re: Excavation Review
Proposed Building Demolition
 95 Melrose Avenue, Ottawa, Ontario

date: March 18, 2025

file: PG7474-MEMO.01

EXCAVATION PROFILE - SECTION A

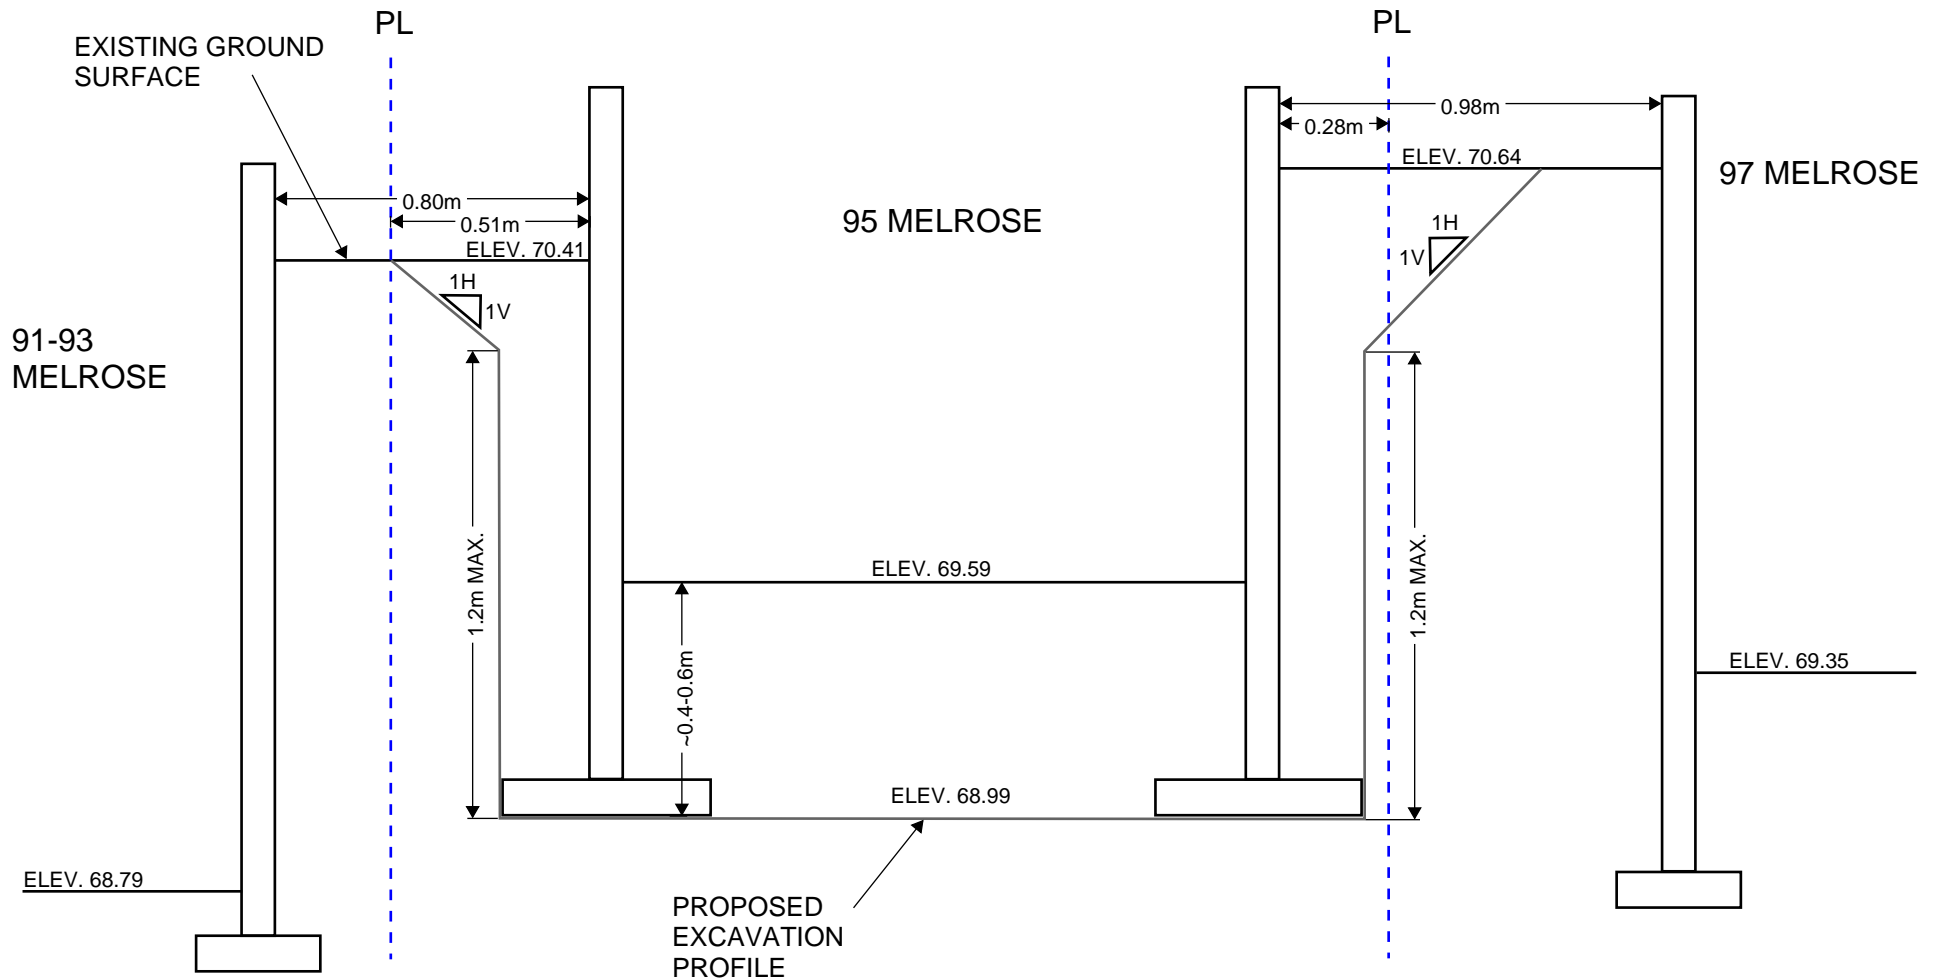
- *Where proposing a sloped excavation, plan of excavation including gradient.*

In general, the excavation side slopes above the groundwater level extending to a maximum depth of 3.0 m should be cut back at 1 Vertical :1 Horizontal (1V:1H) or shallower. A maximum vertical cut of 1.2 m can be completed at the base of the excavation with the proposed 1V:1H slope above. The subsurface soils present at the subject site are considered to be mainly Type 2 and 3 soil according to the Occupational Health and Safety Act and Regulations for Construction Projects.

However, along the south side, sufficient space is not available for a sloped excavation within the property limits. It is recommended that an informed consent agreement form be obtained with the adjacent neighbor to allow for excavation to their foundation wall. A slope excavation could be completed from the foundation wall of the adjacent building to the base of the excavation at a 1V:1H slope above a maximum vertical cut of 1.2 m.

See attached cross-section A-A and B-B in the Excavation Plan & Details drawing attached for the sloping details.
